Design and access statement: Barry Methodist Church

Background: The former Methodist Church on Porthkerry Road in Barry is a grade II listed late 19th Century Church and comprises two buildings – a smaller school hall/chapel and a larger church building. Planning consent was obtained on the 9th of May 2014 to convert the church into 7 houses and the smaller school hall into 4 houses (Planning: 2014/00224/FUL, Listed Building Consent: 2014/00225/LBC).

Issue: Having begun to convert these properties it has become apparent that the kitchen/dining area of one of the church properties (unit 4B), has issues with insufficient daylight in the room and therefore the introduction of new light levels is required.

Sketch to demonstrate the calculation of theta for the day light calculation:

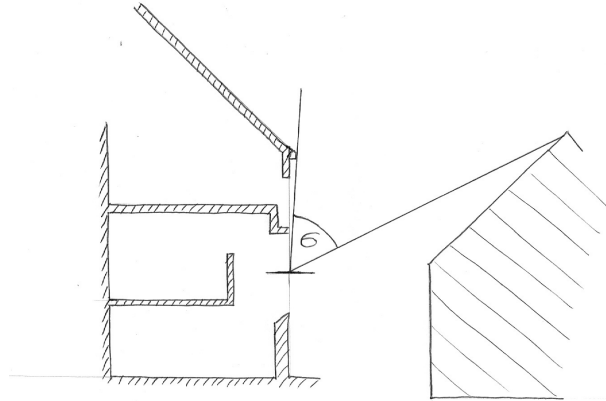
σ = Angle of obstruction measured from the mid point of the window = 57°

$$\frac{57 \times 0.8 \times (2.1 \times 1.2)}{184.98 (1 - 0.5^2)}$$

=0.83%

The daylight factor was calculated to be **0.83%** using the below formula; this fails the BRE minimum recommended interior daylighting figure of 2% for kitchens.

Option 3 - The proposed amendment. This will involve adding a new French window doorset, as is detailed on sketches 05 & 06 (enclosed). This door will be architecturally in keeping with the project and reflect the opening already present in unit 3. This addition will improve access to this room. The effects on community safety, environmental sustainability or movement are not applicable.

Calculating the day light factor with the additional Option 3 windows exceeds the minimum 2% requirement.
